# Staff Report

**Item:** “Brown Street Annexation” (ANX 23-03)

**Tax Lot(s):** 051W18C001200 (1025 Brown St)

## ANX 22-02: Analyses & Findings

EXISTING CONDITIONS

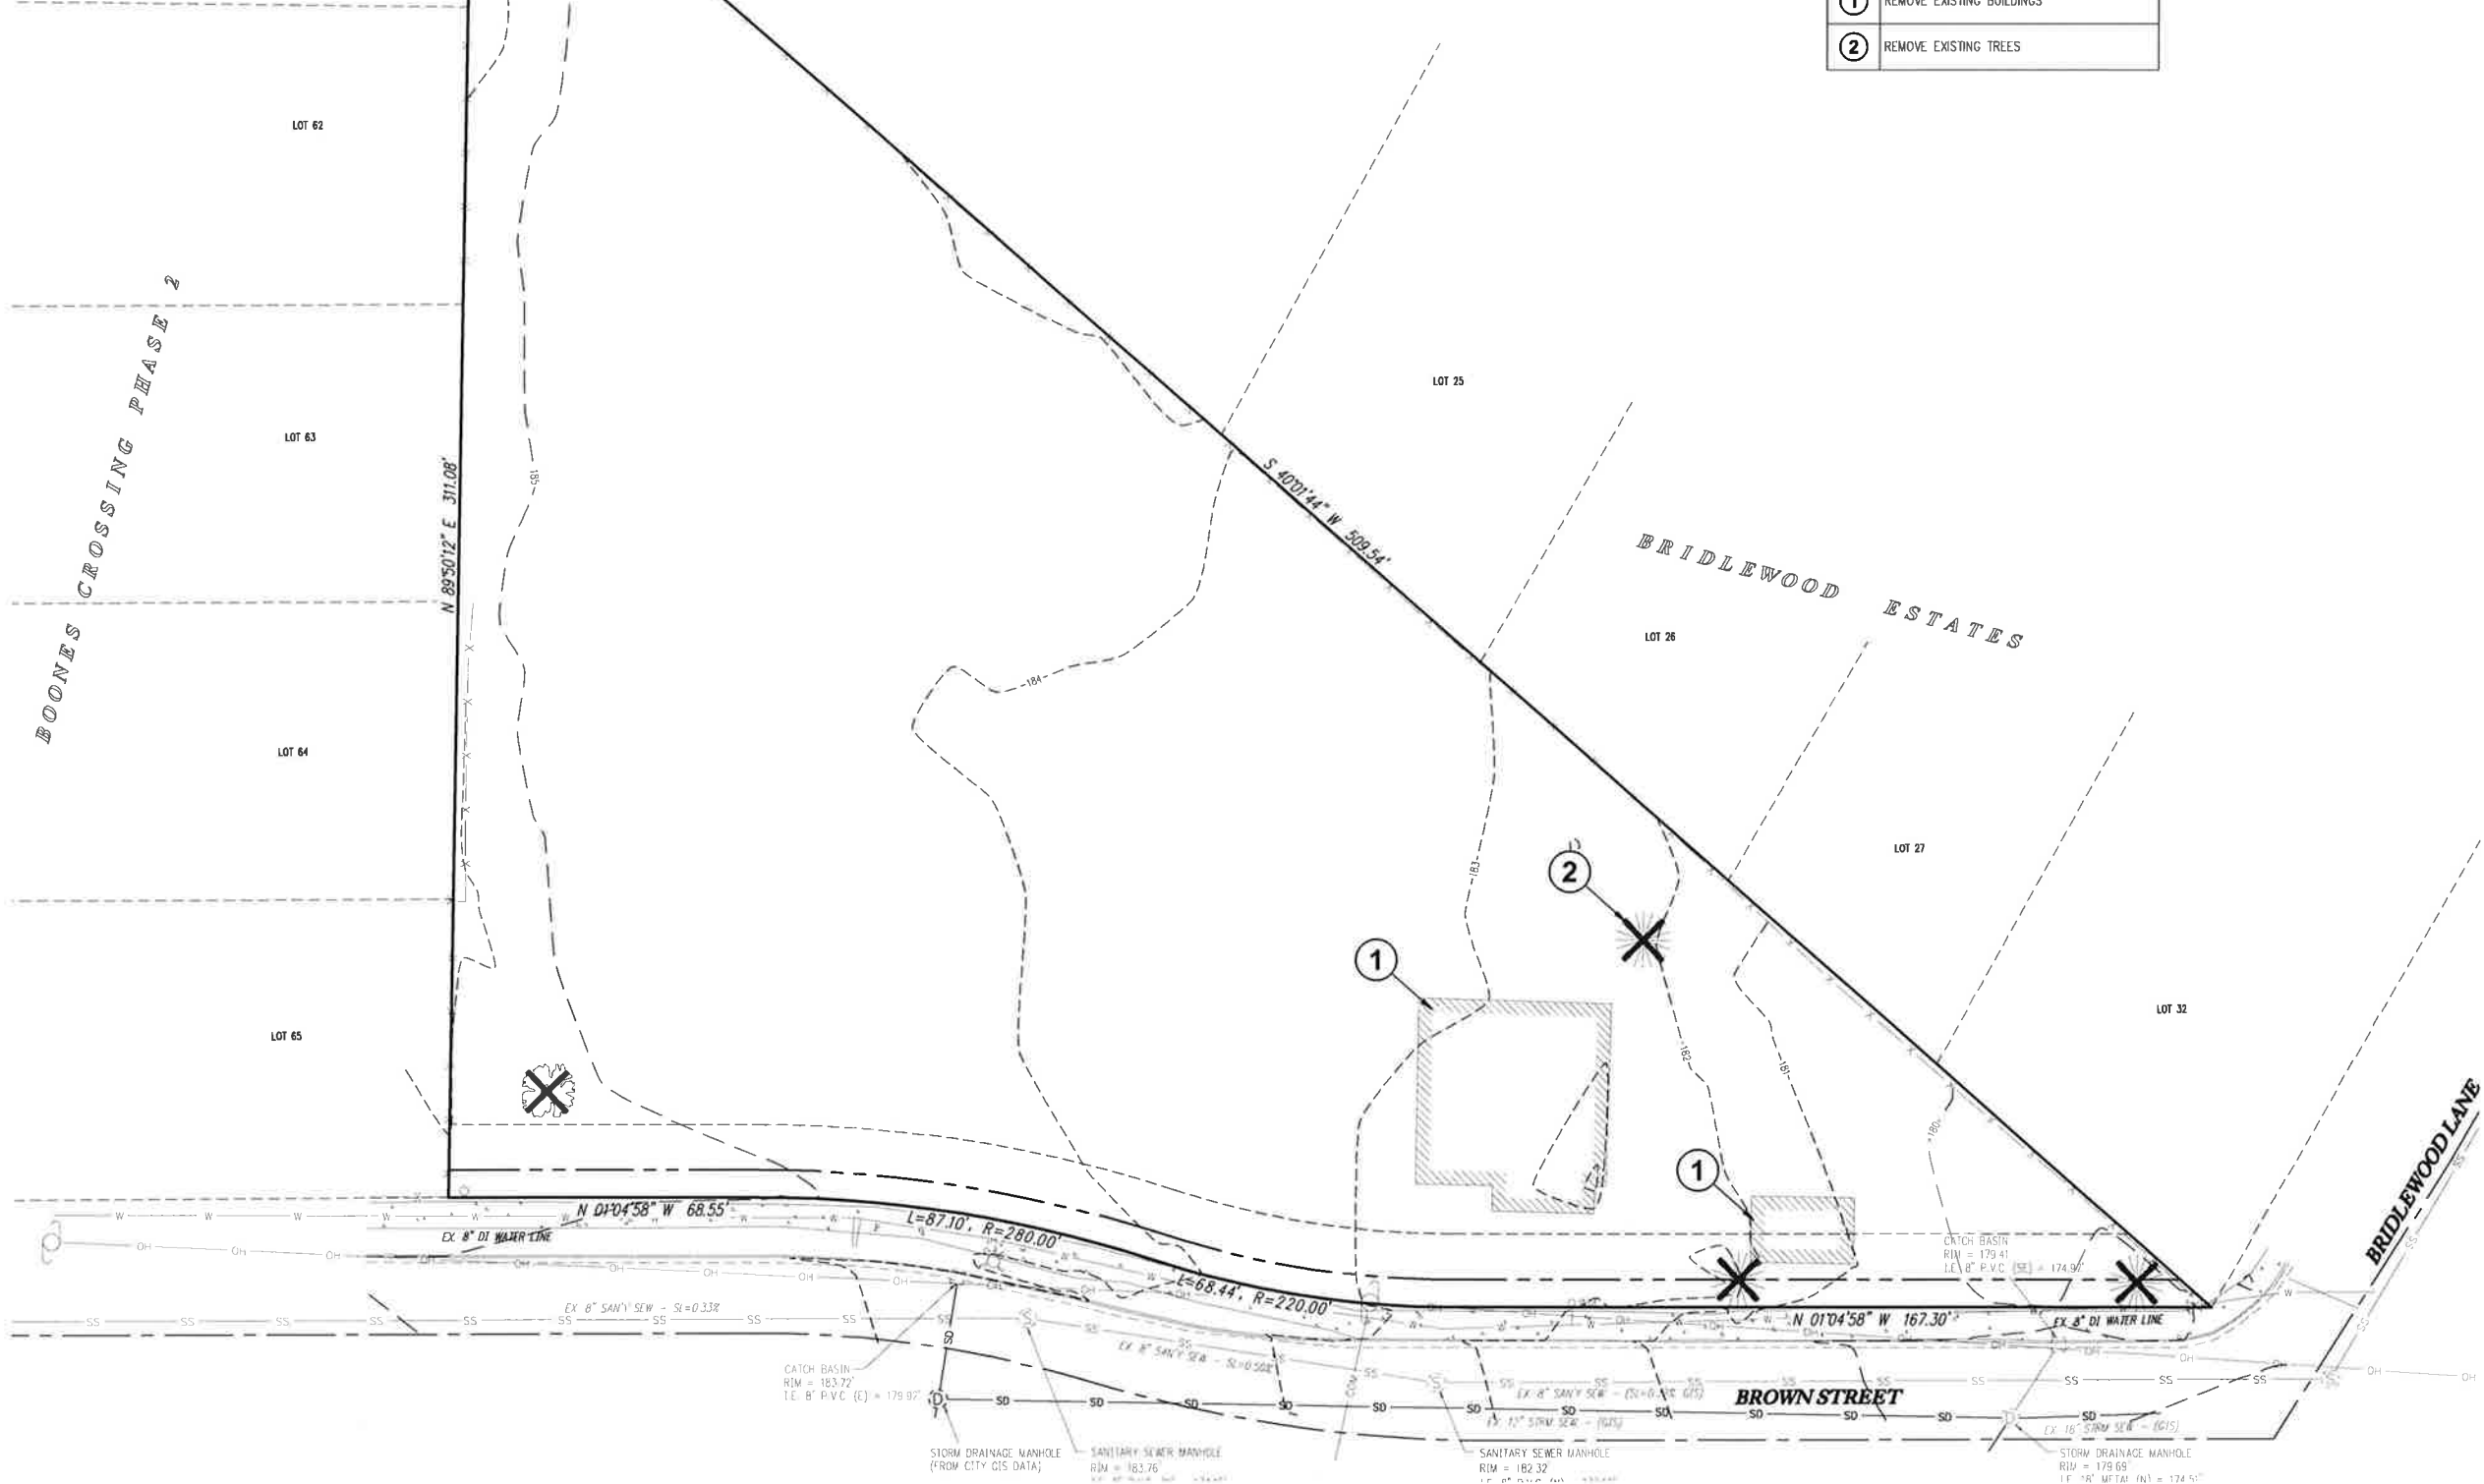
*Revise the existing conditions plan sheet (Sheet 2), which shows trees, to reflect here the information found on narrative p. 30 that there are no Significant Trees.*

**Applicant's Response:** Applicant has revised sheet 2 to show no structures or trees are present on the Property.

**SHEET**  
Building Elevations

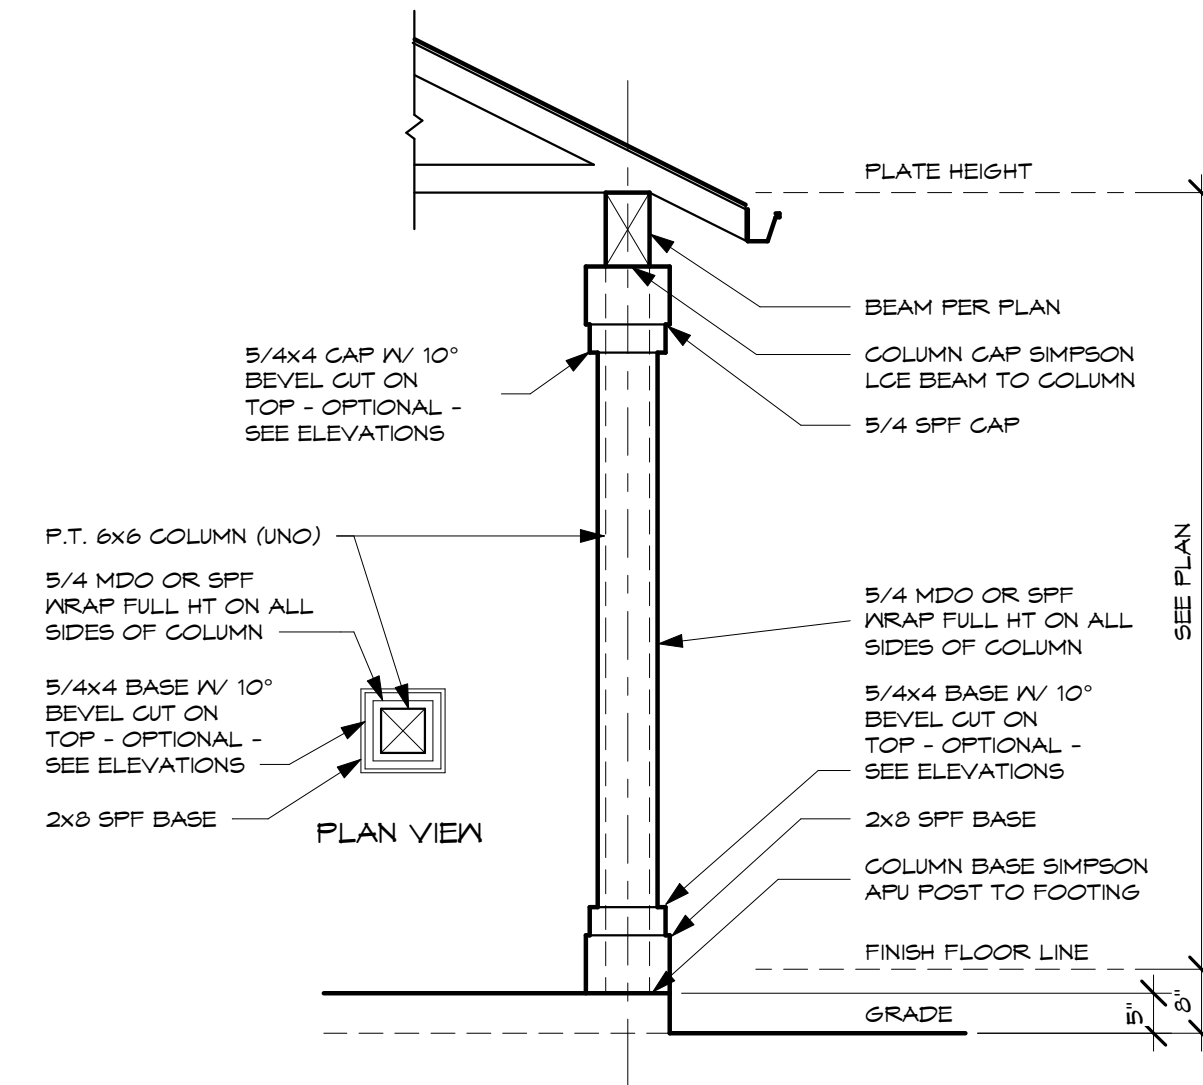
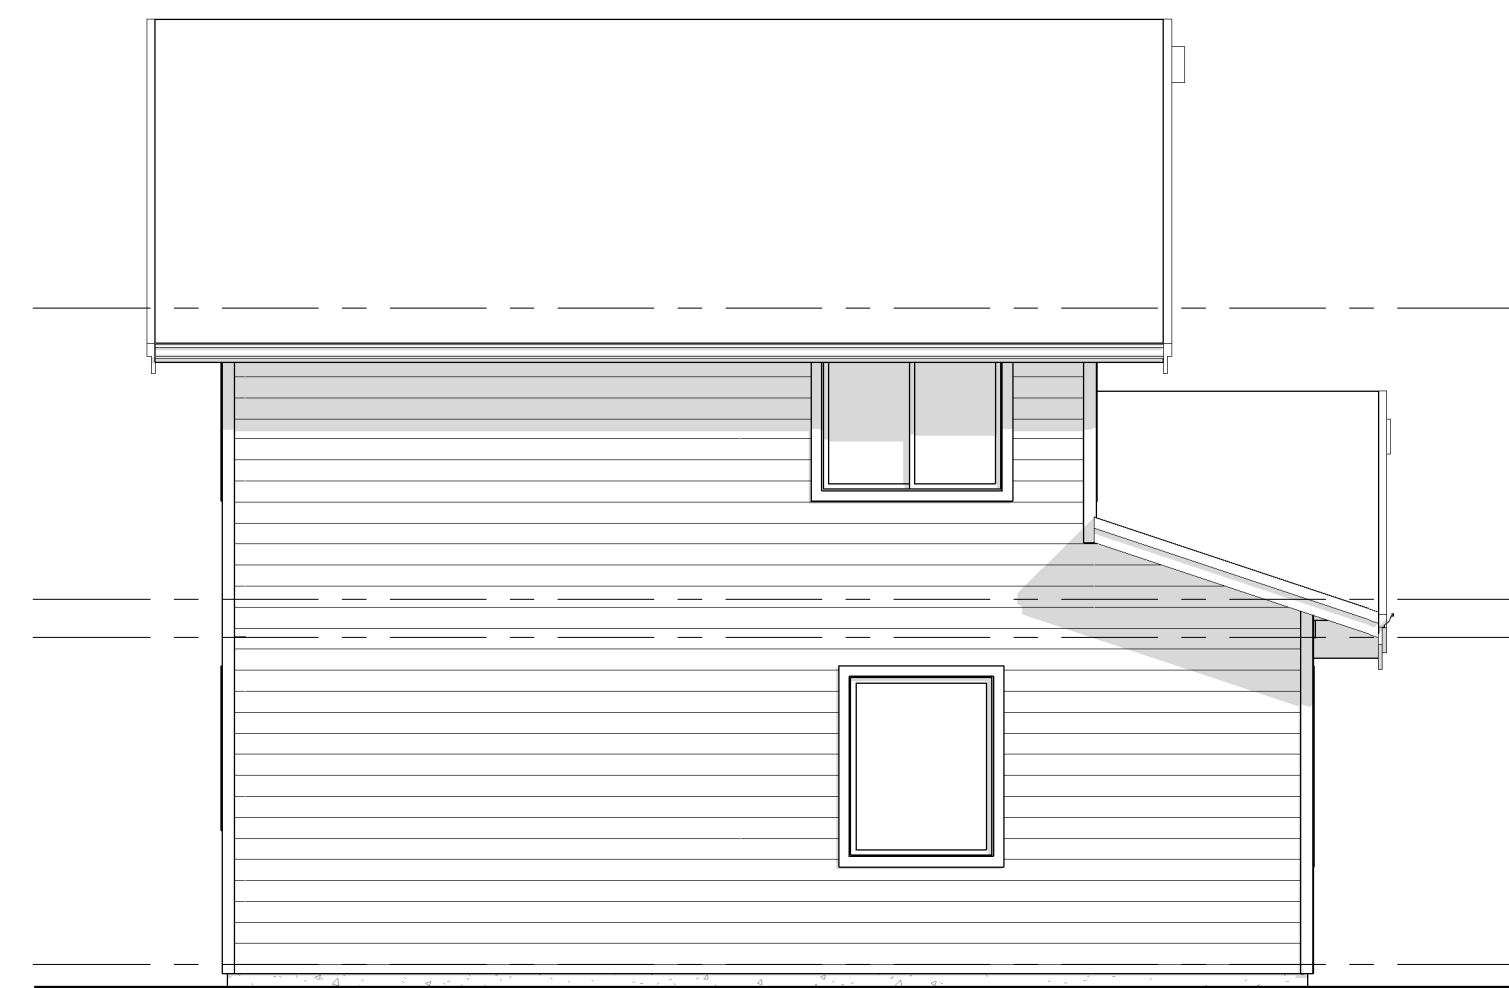
- 3. E3: Revise Sheet A1 elevations to dimension front patio (a) railing height up to max 3.5 ft and (b) railing top member min width of 3 inches.
  - 4. E4: Regarding only the “modern” architectural plan set, the Sheet A1 front patio stone column lacks visual division into clear areas of capital, shaft, and base.

- b. Cottages 1, 2, & 18: Revise or supplement Sheet A1, which tabulates front elevation window area, to do the same for the left side and rear – either for (1) the typical elevations or (2) as new, separate left side and rear elevations specific to the street-facing elevations of Cottages 1, 2, & 18.
